CALIFORNIA COASTAL COMMISSION

APPEAL STAFF REPORT DE NOVO HEARING

Appeal number A-3-SCO-98-101, Bailey/Steltenpohl Mixed Use Davenport Project

Project description Reconstruct a 13,127 square foot building and add 9,791 square feet in three phases to create a 22,918 gross square foot mixed-use building (commercial, residential, and manufacturing); construct a 750 square foot greenhouse; convert an existing boat into a residential structure; and construct a 66 space recessed parking lot (involves grading to depress below existing grade).

COUNTY - APPROVED SITE PLAN

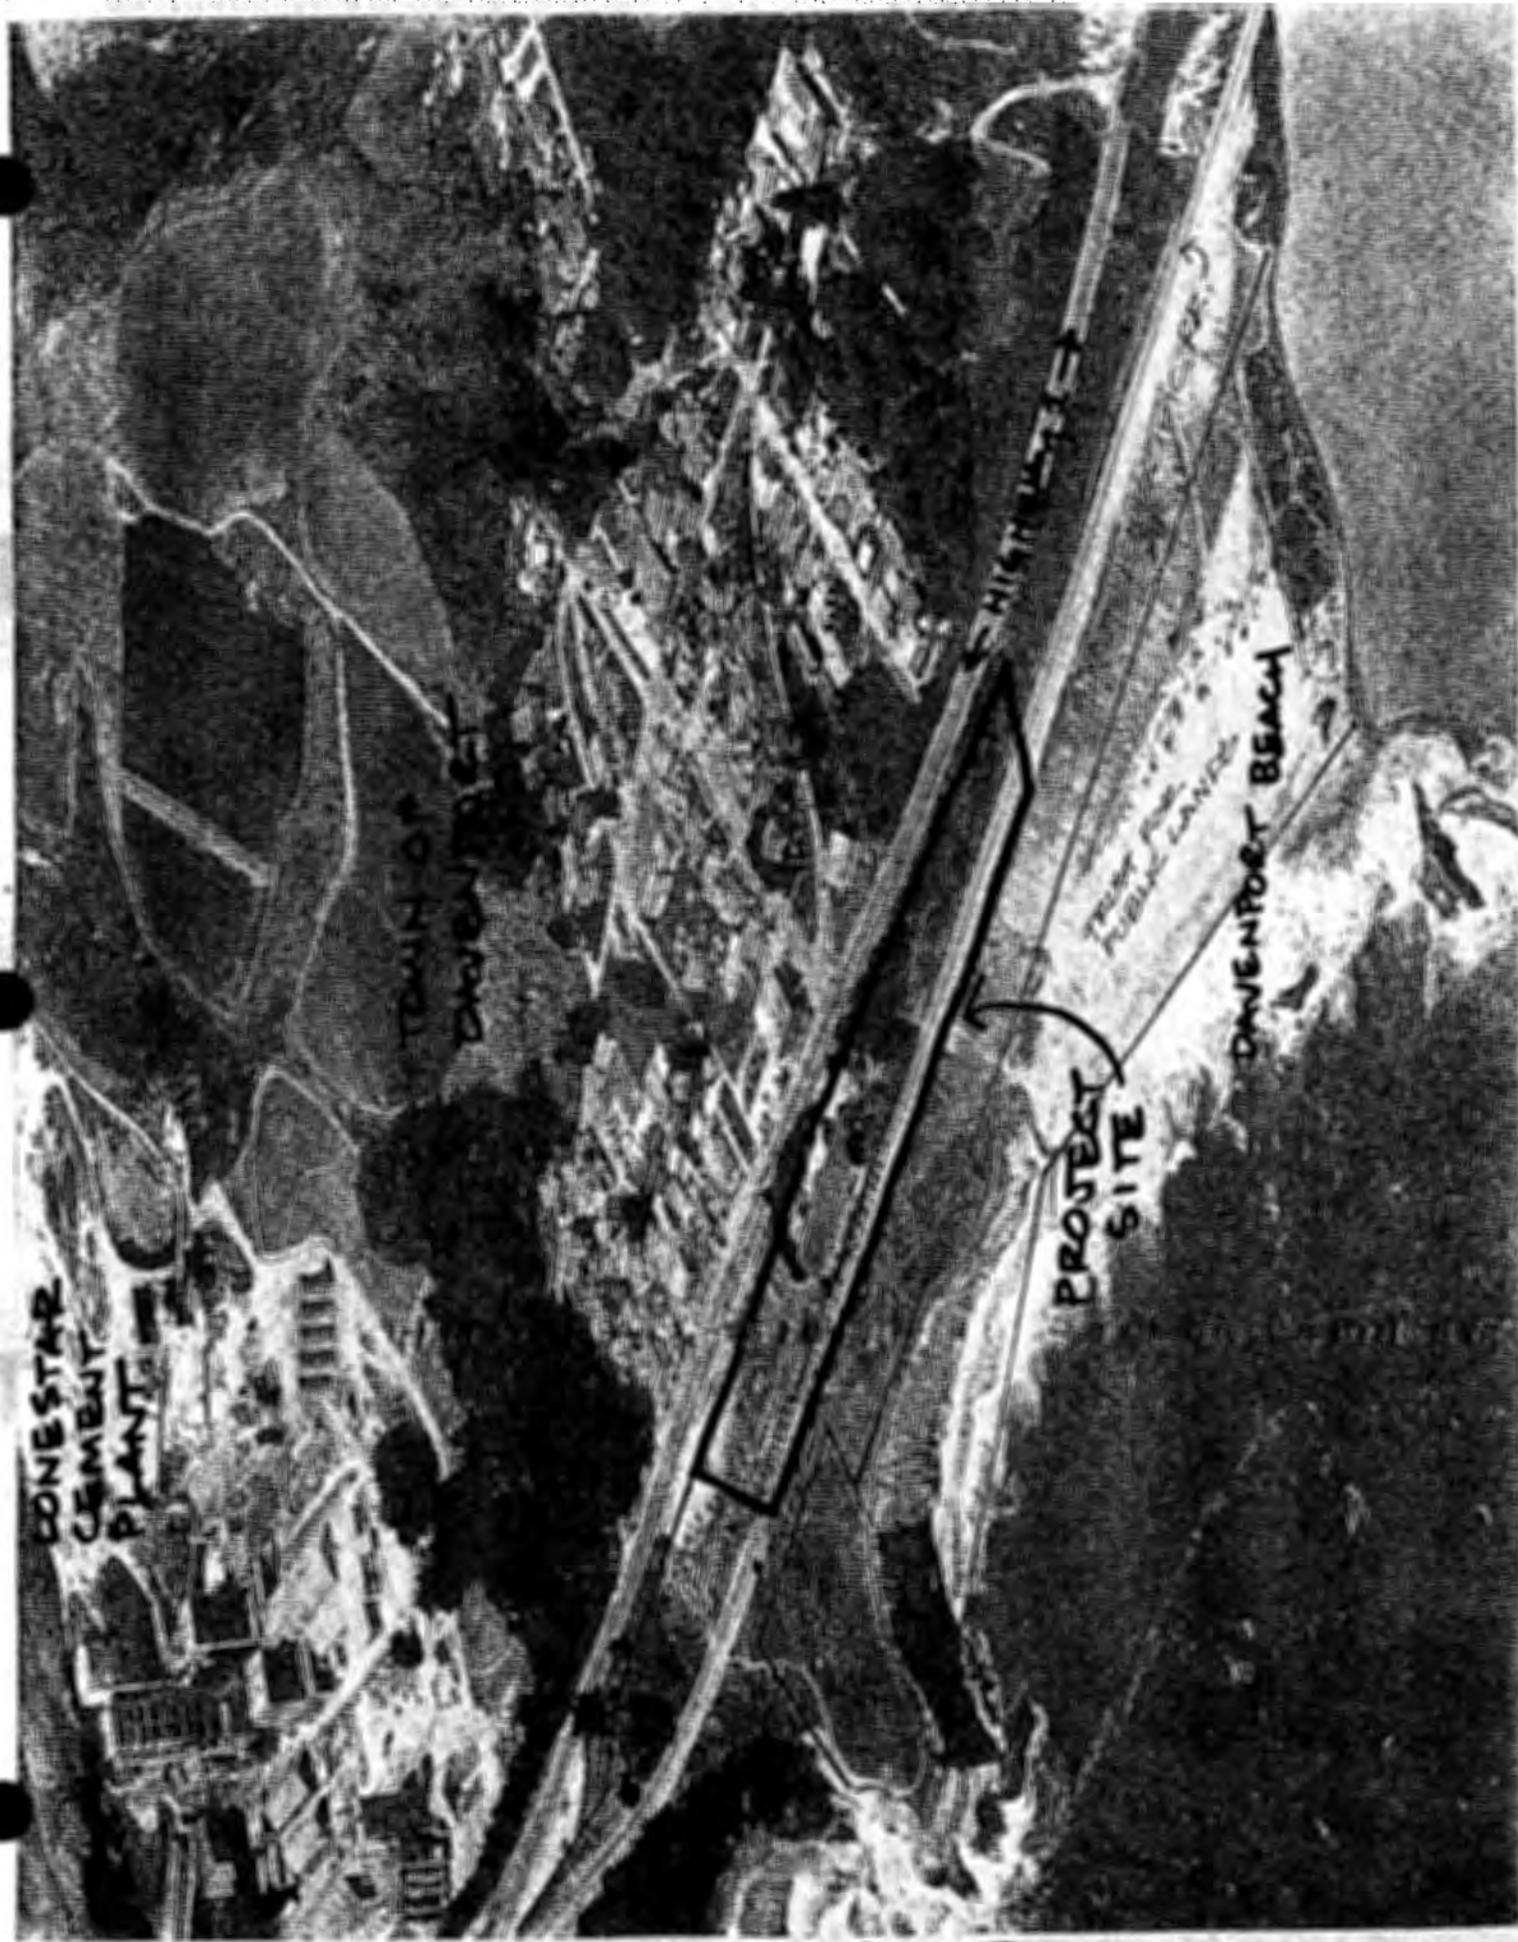
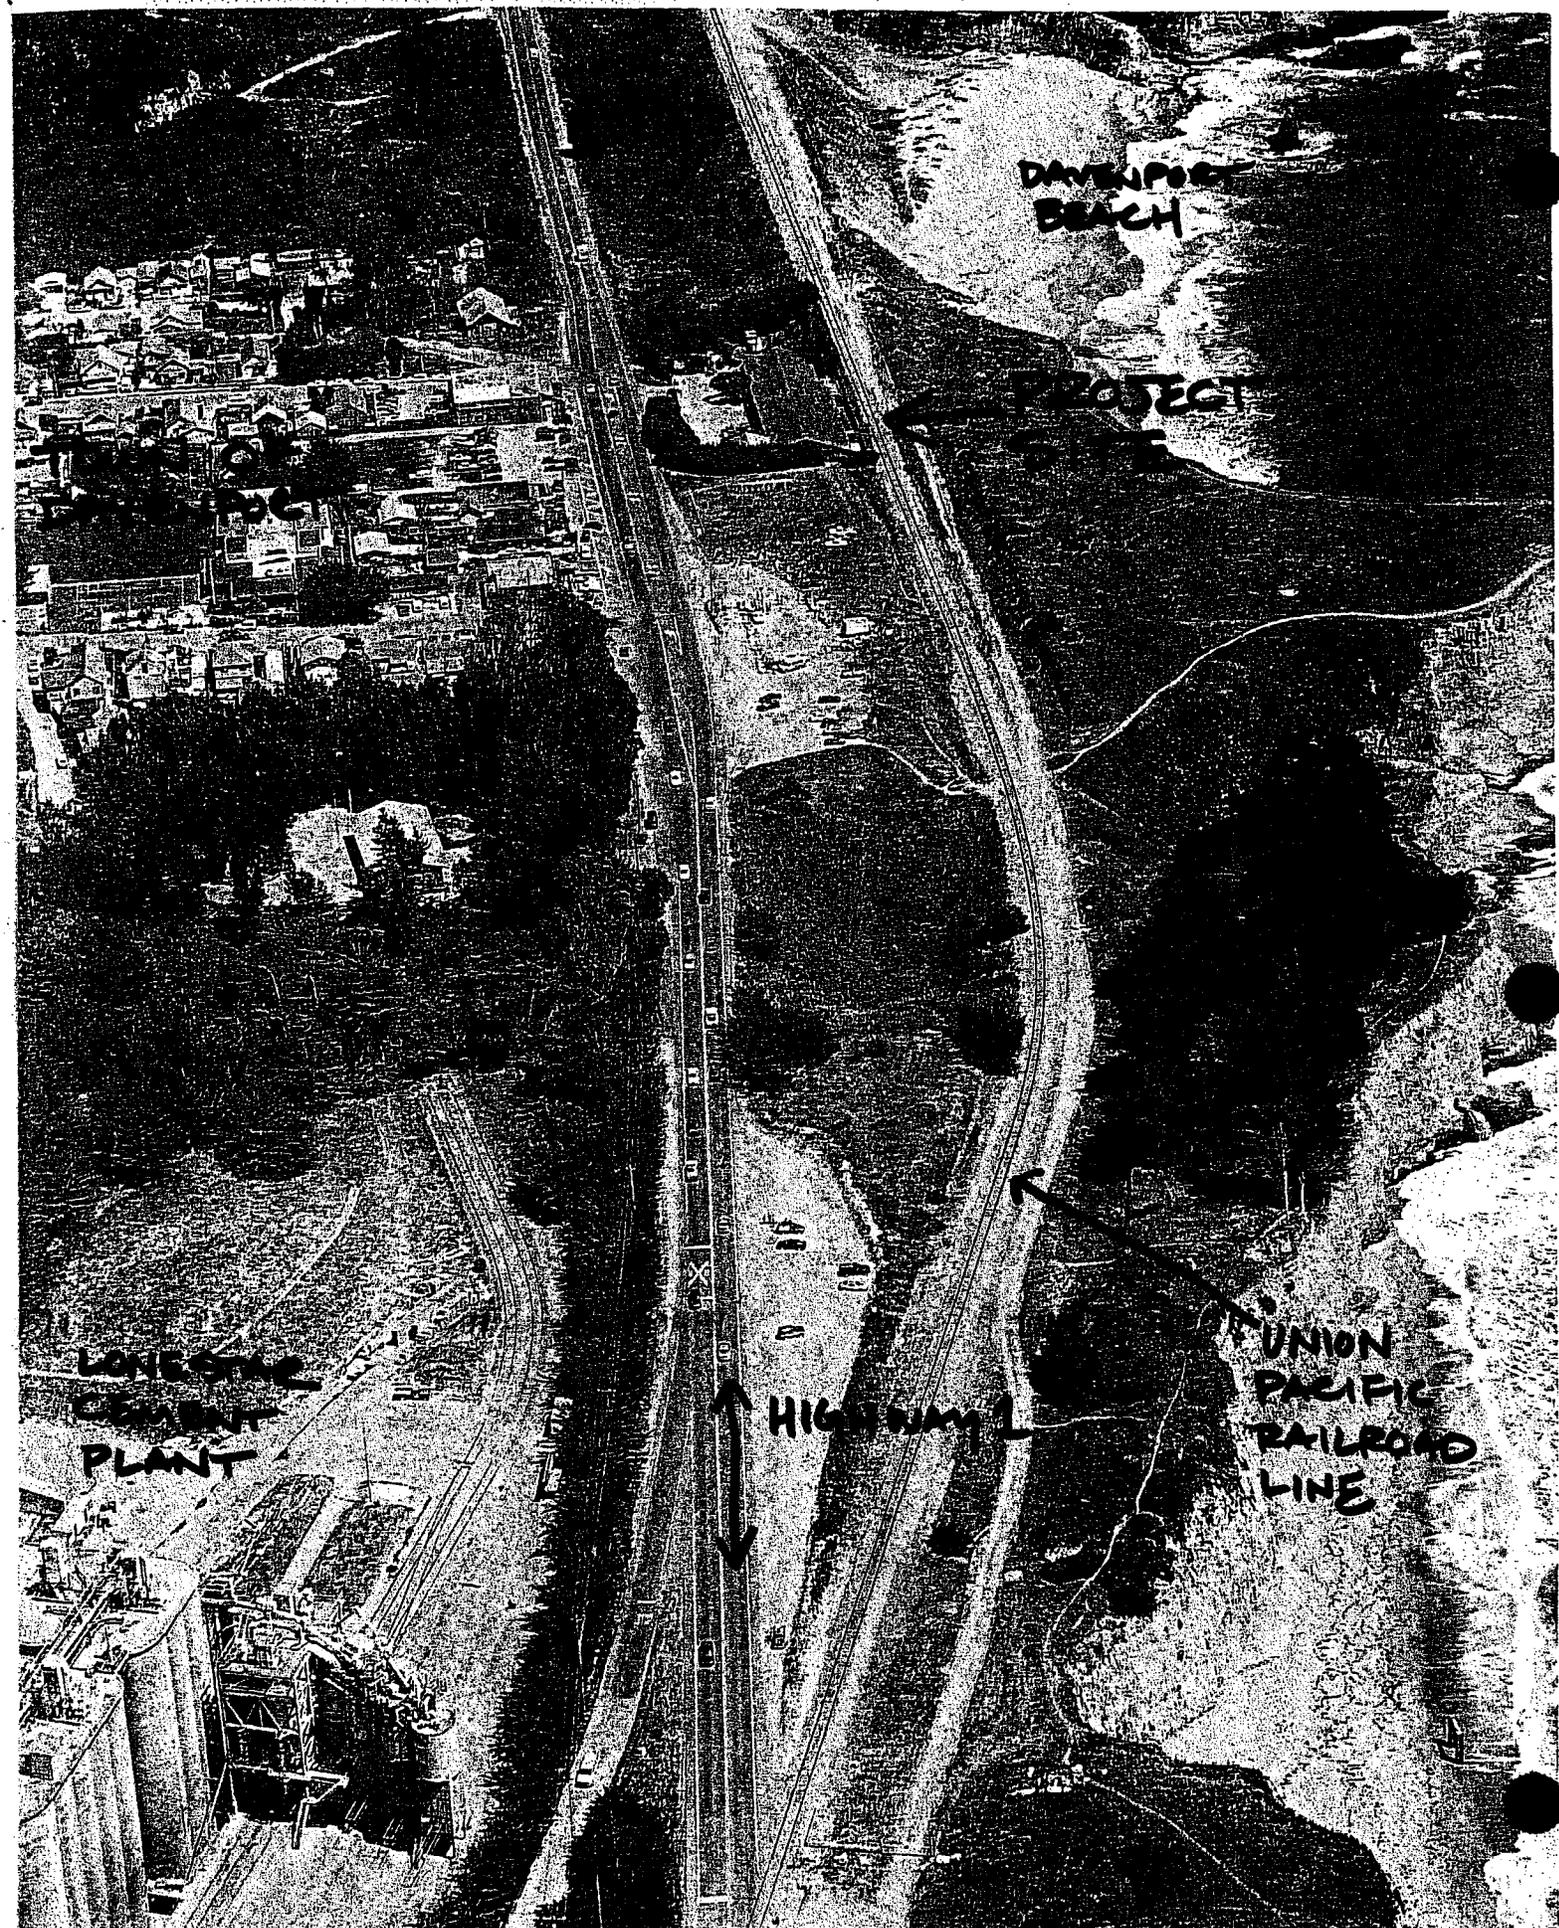
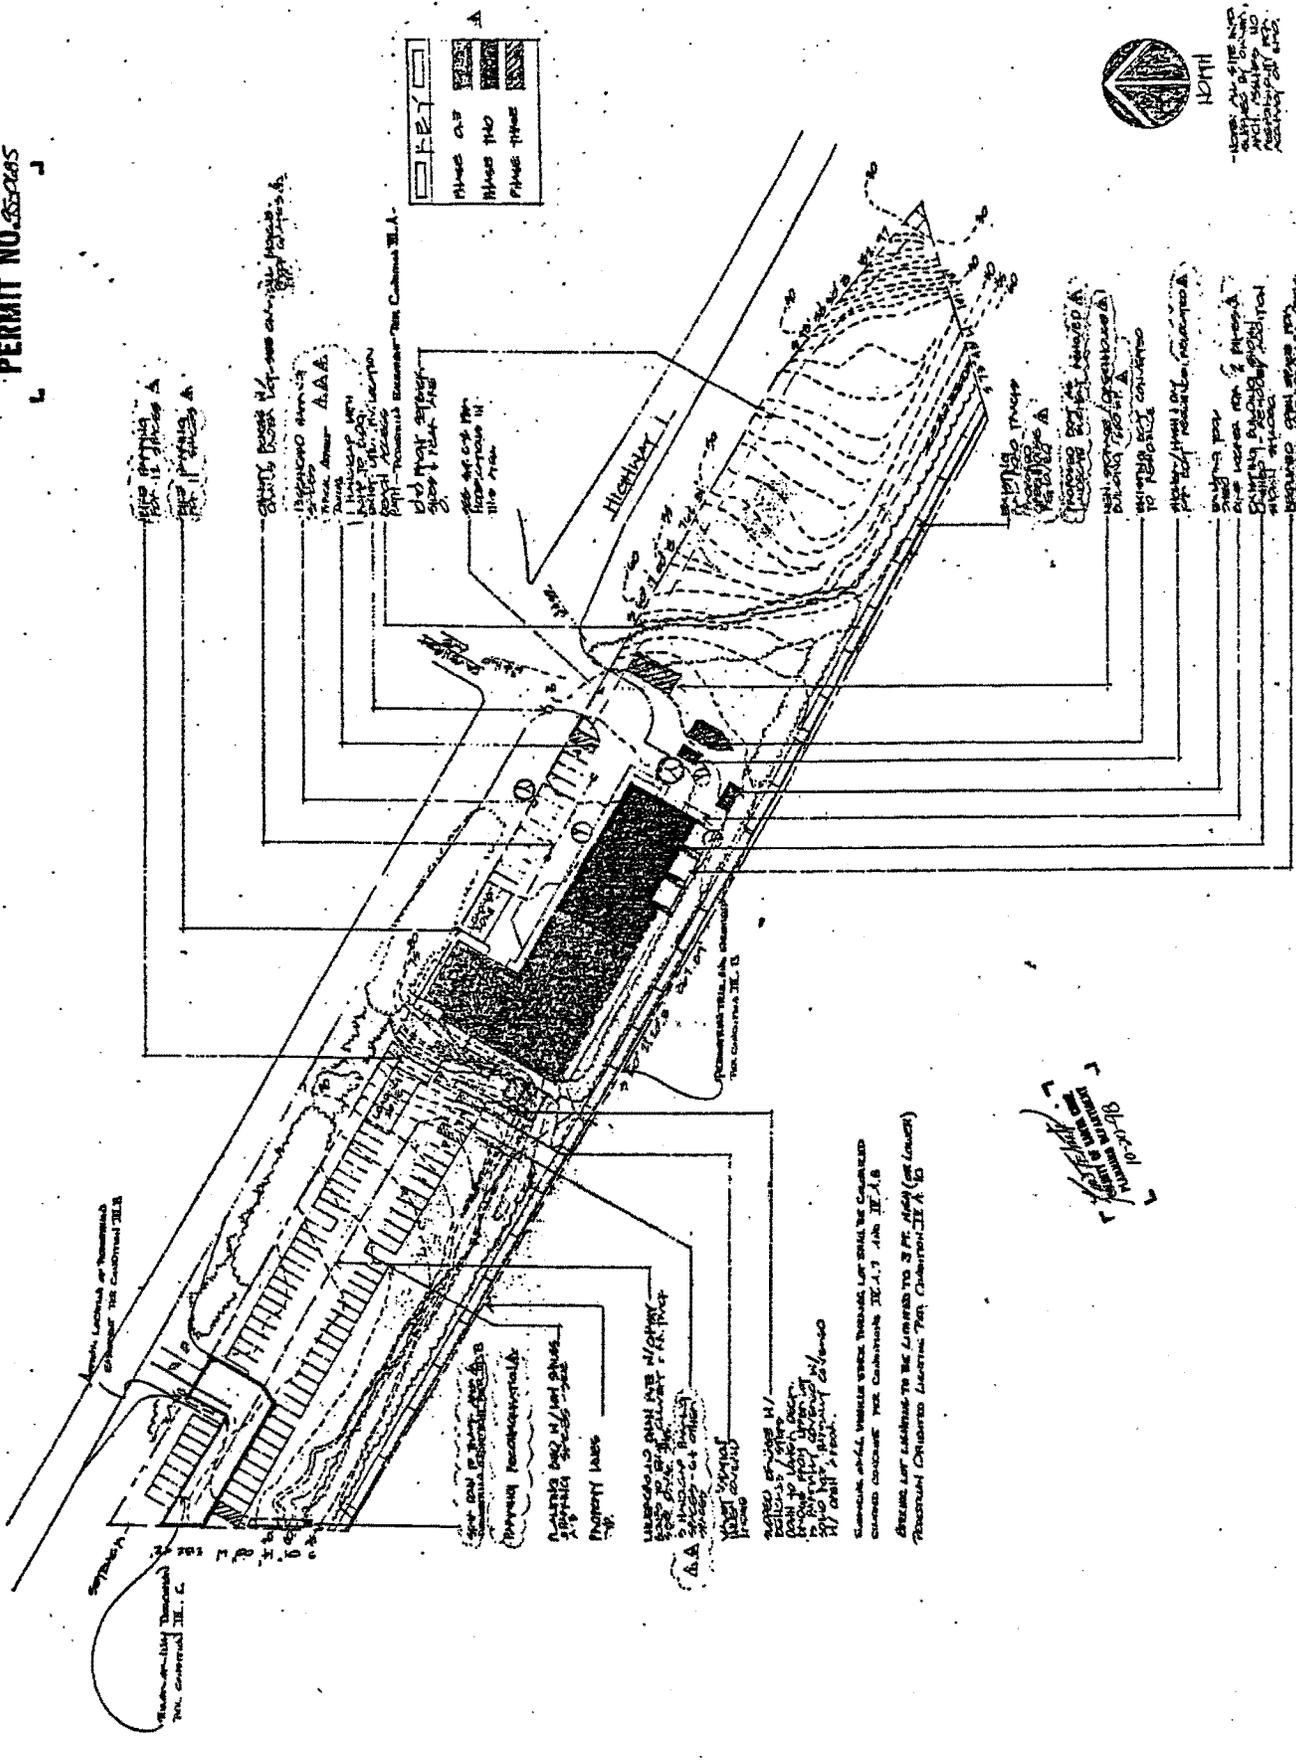
The proposed development would rehabilitate and modify the existing structure at this location to accommodate (mostly) new uses – some of which would be visitor-serving uses. In order to accommodate the new uses, certain exterior and interior architectural modifications are proposed. The County-approved plans show that these modifications include increasing the roof height at the north end of the structure by three to six feet, resulting in a somewhat bulkier appearance and an increased "skyprint" (i.e., profile against the sky). The footprint of the existing structure would also be increased (by 234 square feet according to the County, although the project plans show an approximate 737 square foot increase). The new area of footprint would be in the area nearest to the Highway and would result in a setback from the Highway right-of-way of approximately 4 feet; the existing building currently extends approximately 4 feet into the right-of-way. The County approved a variance for a 0 foot setback as the proposed roof line would extend to the edge of the right of way. See Exhibit B.

3. Revised Plans. **PRIOR TO ISSUANCE OF THE COASTAL DEVELOPMENT PERMIT**, the Permittee shall submit revised project plans to the Executive Director of the Coastal Commission for review and approval. The revised project plans shall be substantially in conformance with: sheets A2, A3, A5, and A6 of the plans submitted to the Commission titled *Davenport Commercial* by Charles J. Franks and Associates (most recent revision dated August 14, 1999); sheets A1, A3.1, A4, A7, A8, A9 A6 of the plans approved by Santa Cruz County titled *Davenport Commercial* by

APPLICANT REVISED PARKING LOT CROSS-SECTIONS (8/31/99) (2002)

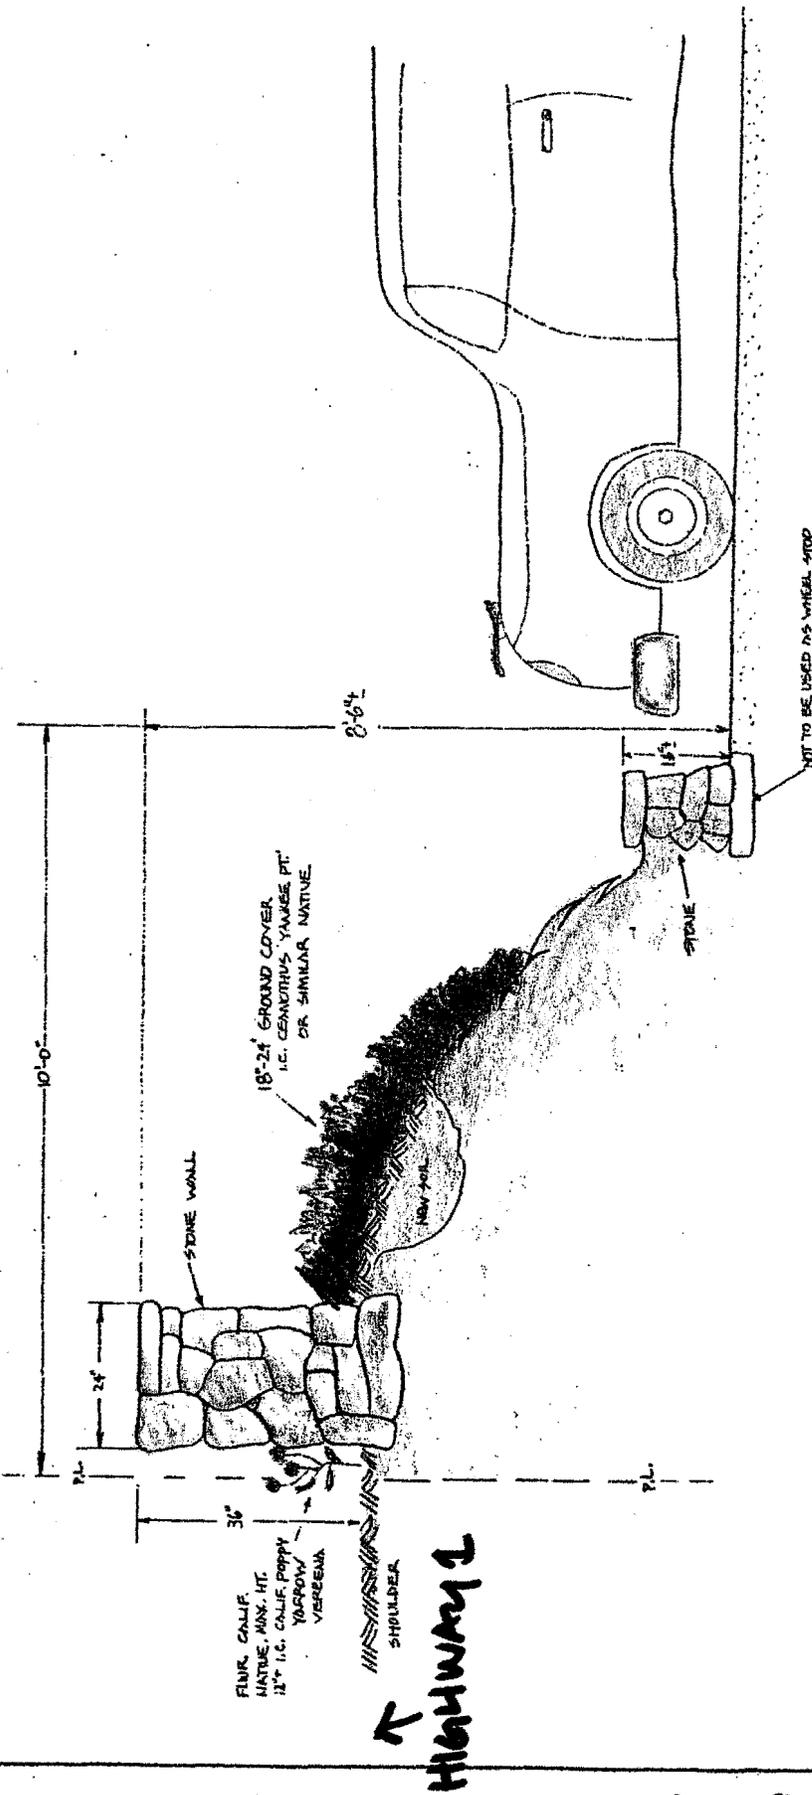
In any event, while mitigations (recessing, landscaping, lighting limitations, and stamped concrete) were required by the County, they are not sufficient to conceal the assembled mass of motor vehicles and would inevitably alter the informality of the existing parking lot. Such upscale improvements are driven by the need to accommodate the increased intensity of use, but will also tend to change the existing community character. This alteration of community character will result both from substituting a prettified "improved" landscape for one which is rough, dirty, and "rustic," and from increasing the collected presence of parked motor vehicles in public view. Reflective glare from the sun shining on the vehicles will detract from the visitor experience and the amassed vehicles in the parking lot, when full, would directly impede the whitewater component of this vista. Thus, the public viewshed would be

7. Plans shall provide that busses and large trucks may only park and/or discharge passengers in the lower (southeast) parking lot.
8. Not more than 36 total parking spaces shall be provided in the upper parking lot, and not more than 20 total parking spaces shall be provided in the lower parking lot, for a total of not more than 56 parking spaces on the Approved Project site. If the Permittee demonstrates to the satisfaction of the Executive Director of the Coastal Commission that more than 56 spaces can be accommodated on the Approved Project site within the combined area consisting of the upper parking lot building envelope (see Exhibit G) and the proposed lower parking lot pavement area (see page 2 of Exhibit D), and consistent with all other parking parameters established in this condition, said spaces shall be allowed provided that they are made available to the general public from the hours of 5 a.m. to 10 p.m..
